SRR-CWDA-2013-00087
Revision 0

**FY2013 Special Analysis for the Saltstone
Disposal Facility at the Savannah River Site:
Quality Assurance Report**

June 2013

Figure 7.2-1: Comparison of 100-Meter MOP Dose Results, Corrected versus Uncorrected

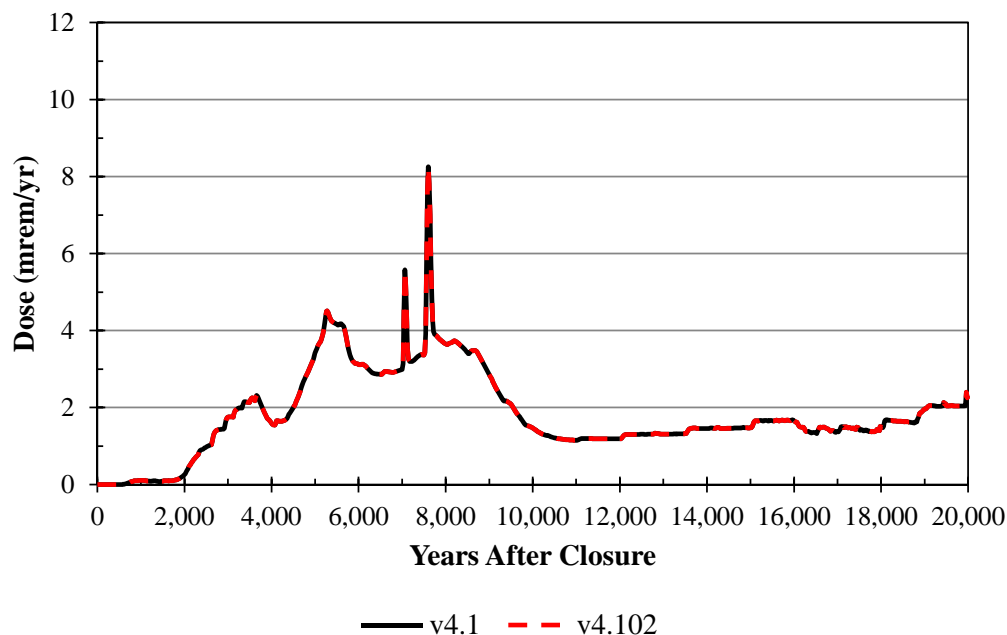
It was determined during checking that all the dose calculations performed in support of the SDF SA used a set of soil-to-plant ratios that was inconsistent from the values recommended in the referenced report *Dose Calculation Methodology for Liquid Waste Performance Assessments at the Savannah River Site*. [SRR-CWDA-2013-00058] The values that were used in the SDF SA came from a superseded, draft iteration of the data set that had been developed for the reference dose calculation report. Table 7.2-1 provides a comparison of the values that were used in the SDF SA versus the recommended values. As shown, the SDF SA applied slightly higher (i.e., conservative) soil-to-plant ratios.

The dose calculations in the SDF SA used 0.2 hrs/day (i.e., a fractional value of 0.0083). This value reflects an average value provided by the U.S. Environmental Protection Agency (EPA), i.e., the average person spends 0.2 hrs/day performing lawn and garden care. [EPA-600-R-090-052F] However, this average value includes the 69% of households that do not have any gardens. The referenced dose calculation report recommended modifying this value to conservatively assume that *all* Members of the Public (MOP) and Inadvertent Human Intruder (IHI) receptors have gardens ($0.0083 \div 0.31 = 0.027$). [SRR-CWDA-2013-00058] In summary, the SDF SA used the average value rather than the recommended value based on a conservative assumption.

A detailed evaluation was performed to disposition these irregularities. For this investigation, a revised dose calculator model was developed (*SRS Saltstone v4.102_20yr_Det.gsm*) and was run using the same GoldSim[®] calculation described within the benchmarking discussion from Section 5.6.2 of the SDF SA. The MOP and IHI dose results from both the uncorrected and the corrected dose calculations were plotted (see Figures 7.2-1 and 7.2-2), showing that these irregularities had a minimal impact on the total dose results. These figures are comparable to Figures 5.6-23 and 5.6-36 of the SDF SA. Over the entire 20,000-year simulation period, the total MOP doses varied by only 2.0E-04 mrem/yr and the total IHI doses varied by only 1.0E-03 mrem/yr. This difference between the two models is four to five orders of magnitude smaller than the respective peak doses, thus these irregularities are considered negligible.

Figure 7.2-3: Comparison of Probabilistic 100-Meter MOP Dose Results, Corrected versus Uncorrected

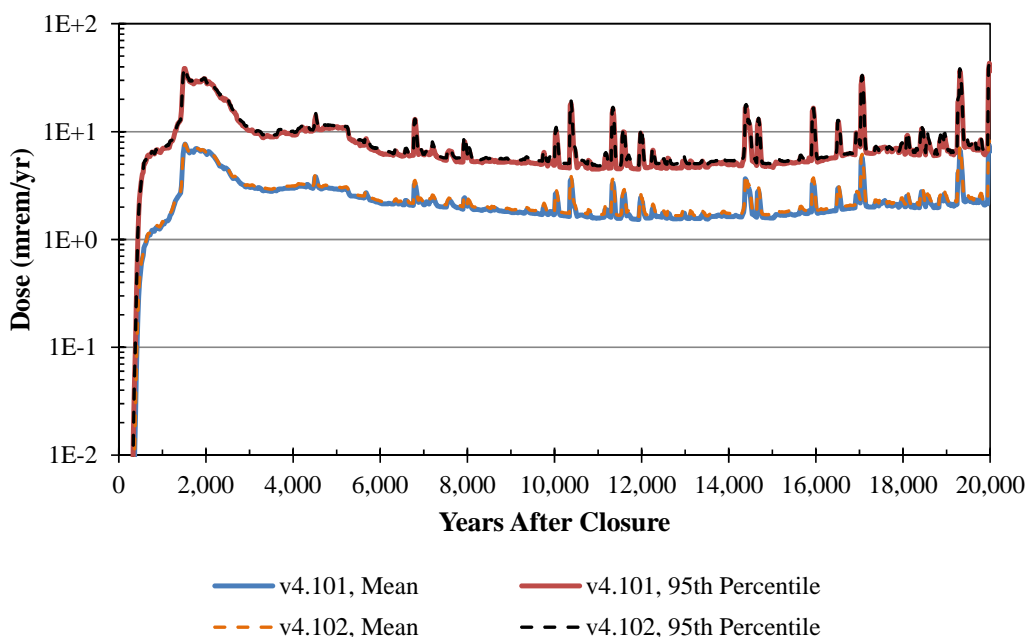
In addition to the soil-to-plant ratio and the garden time fraction discussed above, the referenced dose calculation report describes two soil density parameters used in the dose calculations: (1) the surface density of soil and (2) the bulk sandy soil density. The dose calculation report recommended that these two values be perfectly correlated to each other; however, as was done

in earlier PA dose calculations, these values were not correlated. The dose calculation report also recommended truncating the sampled values of the surface density parameter, but this value was not truncated in the SDF SA. Finally, the bulk sandy soil density applied a standard deviation of 100 kg/m^3 , whereas the dose calculation report recommended a standard deviation of 120 kg/m^3 .

These irregularities only affected probabilistic modeling. Correcting these values would reduce variability in the sampling results for these parameters, but not significantly affect the statistical outcome of such sampling (e.g., the mean of the sampled value would not be significantly affected). Note that these parameters did not show up as being important during the sensitivity analyses in the SDF SA; therefore, reducing parameter variability is not expected to significantly affect the outcome. Thus, revising the uncertainty or sensitivity analyses is not necessary to evaluate this irregularity. Instead, a probabilistic model that incorporates corrections to all of the aforementioned irregularities was run for 1,000 realizations and the 95th percentile and the mean was compared to the equivalent dose results from the SA model file: *SRS Saltstone v4.101_20yr_RS01.gsm*, as described below.

A detailed evaluation was performed to disposition these irregularities. For this investigation, a revised dose calculator model was developed (*SRS Saltstone v4.102_20yr_RS01.gsm*) and was run using the same GoldSim[®] calculation as used in the Uncertainty Analysis discussion from Section 5.6.4 of the SDF SA (using a random seed of 1, the equivalent SDF SA model file is: *SRS Saltstone v4.101_20yr_RS01.gsm*). The MOP dose results from both the uncorrected and the corrected dose calculations were plotted (see Figures 7.2-3), showing that these irregularities had a minimal impact on the total dose results. This figure is comparable to Figure 5.6-40 of the SDF SA. In general, the doses increased between 1 % and 5 %. For example, the peak of the mean in 10,000 years was 7.66 mrem/yr in *SRS Saltstone v4.101_20yr_RS01.gsm* compared to 7.73 mrem/yr in *SRS Saltstone v4.102_20yr_RS01.gsm*. Given that the probabilistic model results between individual realizations can vary by orders of magnitude, this percentage increase is considered negligible.

Figure 7.3-1: Comparison of 100-Meter MOP Doses Using the Latest Soil K_d s for Iodine

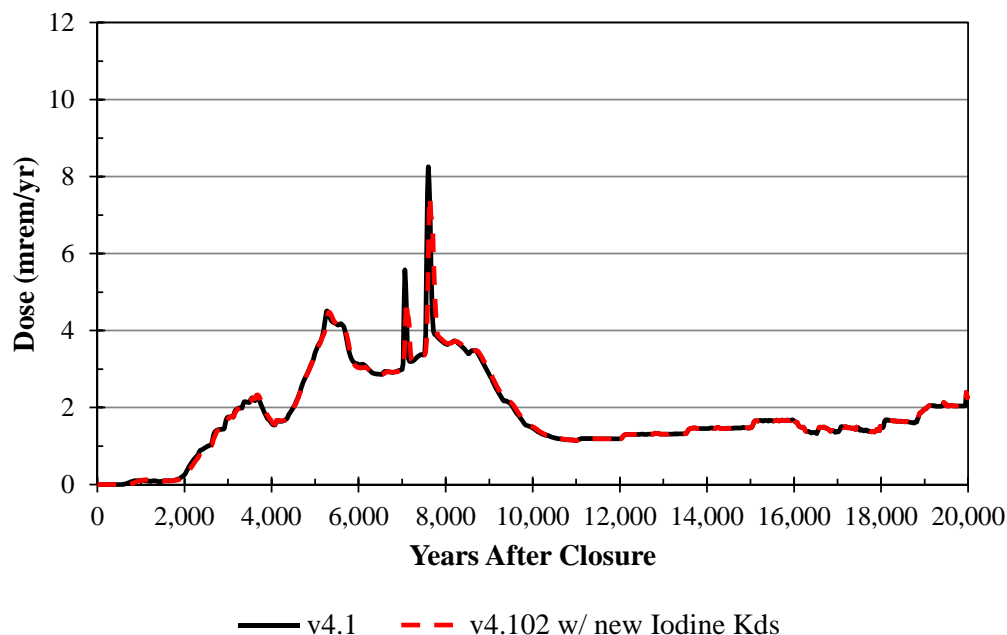
Upon completion of the initial draft of the SDF SA, a new technical report, *Radioiodine Geochemistry in the SRS Subsurface Environment*, was issued with revised site-specific iodine K_d s in SRS soils. [SRNL-STI-2012-00518] In sandy soils, the iodine K_d increased from 0.3 mL/g to 1.0 mL/g. Similarly, in clayey soils, the iodine K_d increased from 0.9 mL/g to 3.0 mL/g. By applying the cement leachate factors from Table 13 of SRNL-STI-2009-00473, the new leachate-impacted soils K_d s are 0.1 mL/g and 0.3 mL/g for sandy and clayey soils, respectively.

Although the change is likely to reduce the expected dose by retarding the transport of I-129, it is also possible that the new values could cause the I-129 dose peak to occur at the same time as one of the Tc-99 peaks, thus potentially resulting in a higher overall peak dose. Therefore, these new K_d values were evaluated using the model file *SRS Saltstone v4.102_I_Kd.gsm*.

Figures 7.3-1 and 7.3-2 show that the new K_d values have no adverse impact on the overall peak doses. The new K_d values do not significantly affect the timing of the peak doses, but does decrease the peak doses by about 10 %. The peak MOP dose decreased from about 8.3 mrem/yr to about 7.5 mrem/yr and the peak IHI dose decreased from about 36 mrem/yr to about 33 mrem/yr. Therefore, the results discussed in the SDF SA may be considered conservative.
